Docket Item # 10
BAR CASE # 2009-0207

BAR Meeting
October 7, 2009

ISSUE: Alterations
APPLICANT: Mr. and Mrs. B. Patrick Costello, Jr.
LOCATION: 807 South Royal Street
ZONE: RM / Residential

STAFF RECOMMENDATION: Staff recommends denial of the application.

Figure 6. Specifications for proposed replacement windows.

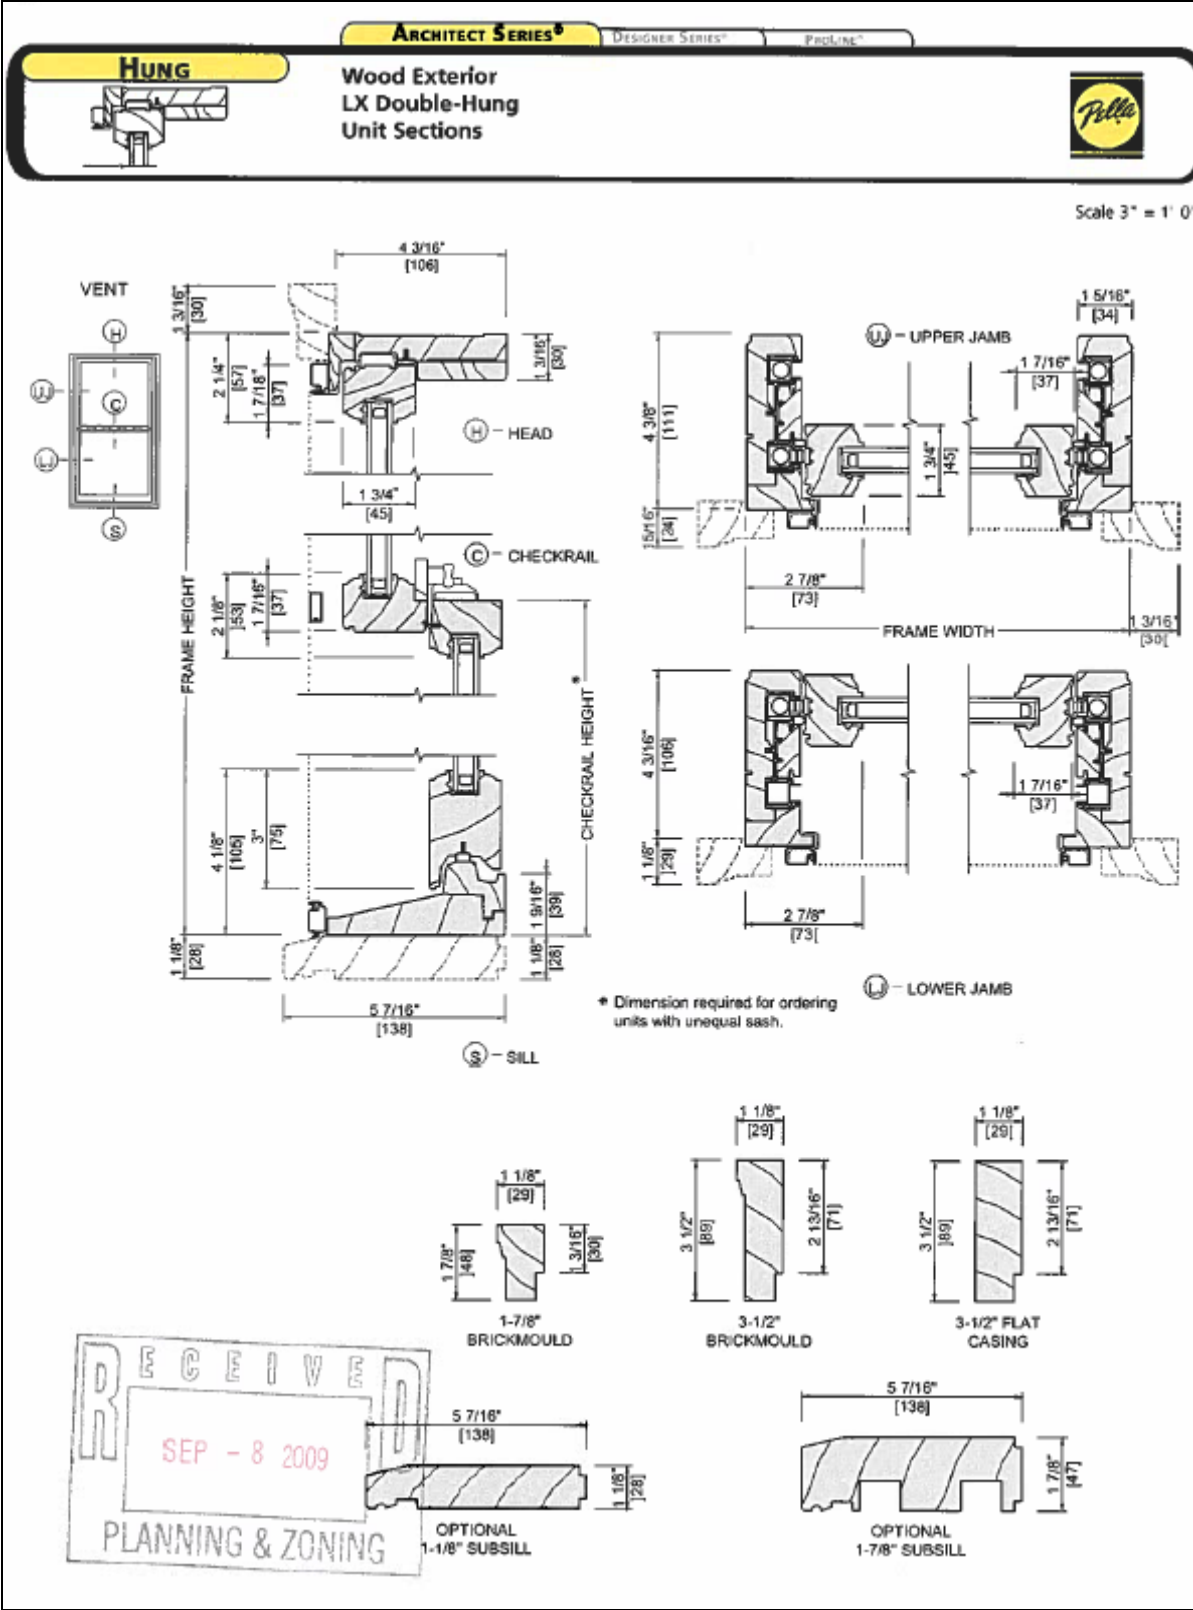
The applicant is requesting approval of a Certificate of Appropriateness for replacement windows on the front (east) elevation of 807 South Royal Street. The existing windows appear to be the original windows and are true divided light, singled-glazed wood windows. There are currently aluminum storm windows as well. The proposed replacement windows are simulated divided light, double-glazed wood windows manufactured by Pella. They are proposed to match the existing light configuration which includes two six-over-six windows and one nine-over-nine window. The proposed windows will have a 7/8 inch muntin with an interior spacer bar and exterior applied muntins.

In reviewing the submitted application, Staff finds no convincing reason why the original windows cannot be retained and repaired. The photographs indicate that the existing windows are operable and in good condition and a site visit by Staff confirmed this condition. Staff recommends that the existing windows be repaired and retained and that the applicant consider new storm windows as necessary. Many studies have shown that a wood window in good condition fitted with a storm window can be as energy efficient as the more expensive replacement window, without the loss of historic fabric. An energy audit is often necessary to determine the best course of action for energy efficiency. Many homeowners mistakenly believe that a wholesale window replacement will improve energy efficiency when in reality many smaller, less expensive modifications, such as new weatherstripping/caulking, new insulation, and repairs to existing windows and storms, can achieve greater gains in energy efficiency at much less cost. In addition, historic windows were made using higher quality materials such as

IV. STAFF RECOMMENDATION: Staff recommends denial of the application.
